in re	Application of:	(
Masaki Yamamoto et al.				
Seria	l No. To Be Assigned)		
Filing Date: Herewith				
For:	Television Tuner Which Maintains UHF Band Tuning Circuit Bandwidth Constant in Low to High Band Range)

PRELIMINARY AMENDMENT

FIG. 1

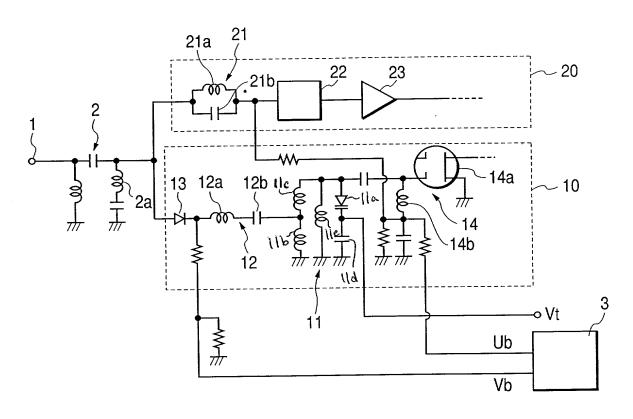
Please replace Fig. 1 with the corrected Fig. 1 enclosed herewith. The corrections to the figure have been marked in red. Applicants respectfully request that the Examiner approve the corrections. Applicant will submit corrected formal drawings upon receiving a Notice of Allowance.
